Commissioner for Patents Amendment dated July 29, 2005 Response to Office Action dated March 1, 2005 Page 6 of 11 Serial No.: 09/965009 Art Unit: 2142 Examiner: Hollar Docket No. AUS9 2001 0429 US1

REMARKS/ARGUMENTS

FIG. 1

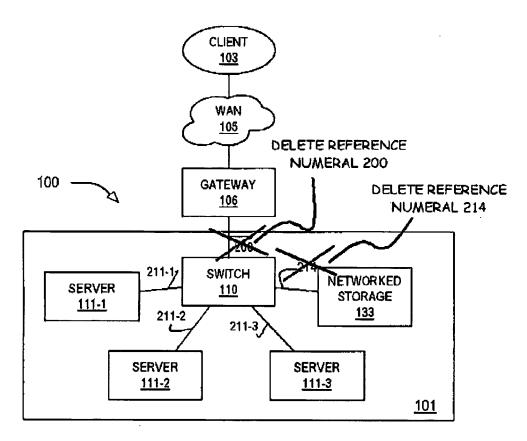
The attached sheet of drawings includes changes to FIG. 1. This sheet 1 (of 4), replaces the original sheet 1 (of 4). As shown on the attached Annotated Sheet Showing Changes, reference numerals 200 and 214, which were not referred to in the specification as filed, have been deleted. No other changes have been made.

The Office Action required correction because of FIG 1 because reference numerals 200 and 214 shown in FIG. 1 were not mentioned in the specification. Applicant has submitted a proposed replacement drawing sheet for FIG. 1 and an annotated sheet showing changes in which reference numerals 200 and 214 have been deleted. Applicant believes that FIG. 1 of the proposed replacement drawing sheet complies with the requirements of 37 CFR 1.84 and Applicant respectfully requests the Examiner to enter the proposed replacement drawing sheet and withdraw the objection. The Examiner also objected to FIG. 4 for including reference numeral 410 not mentioned in the specification. In response to this objection, Applicant has amended the specification as indicated above to include a reference numeral 410 in the appropriate passage. Applicant believes that this amendment to the specification obviates the drawing objection and Applicant therefore requests the Examiner to withdraw the object to FIG. 4.
